**CITY OF EAST PALO ALTO, CALIFORNIA
DEPARTMENT OF PUBLIC WORKS – ENGINEERING DIVISION**

ADDENDUM No. 4

**US 101 / UNIVERSITY AVENUE INTERCHANGE IMPROVEMENTS
CIP-ST-14**

Date: 03/07/2023

MOTORIST INFORMATION PLAN
NO SCALE

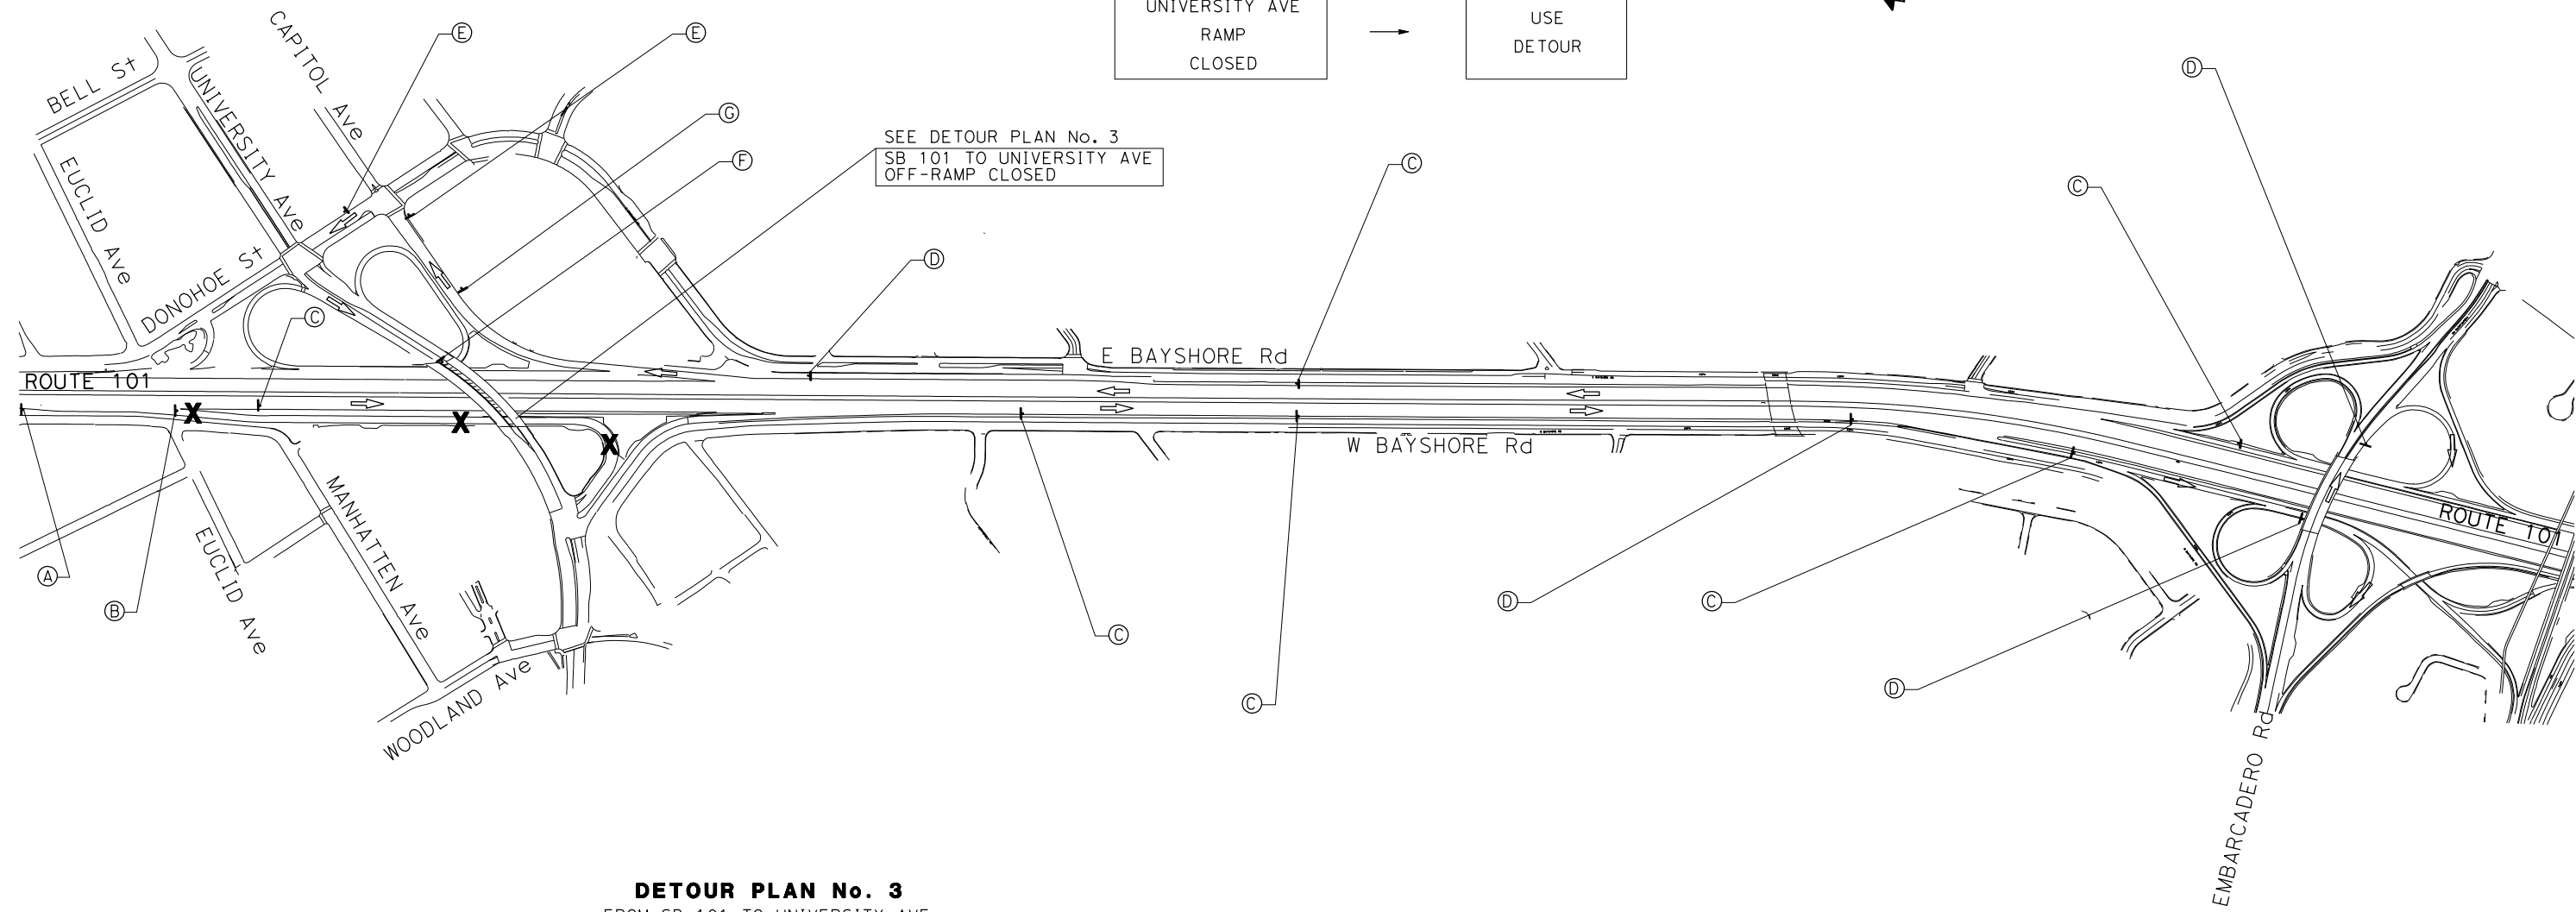
1. After plan sheet 43 of 136, “Motorist Information Plan M-2,” replace plan sheet 44 of 136, “Motorist information Plan MI –” and plan sheet 45 of 136, “Motorist Information Plan MI -” with attached plan sheet “Motorist Information Plan MI-3” and plan sheet “Motorist Information Plan MI-4,” respectively.
2. Replace plan sheet 75 of 136, “Irrigation Sprinkler Schedule ISS-1” with the attached plan sheet having the same name.
3. Replace plan sheet 79 of 136, “Plan Legend PL-1” with the attached plan sheet having the same name.

18. In the Remarks section of Chart. No. J2 in Section 12-4.02C(3)f, add the following: “Detour to the next off-ramp” and replace “See project plans sheet MI-3 for detour.” with “See project plans sheet MI-3.”
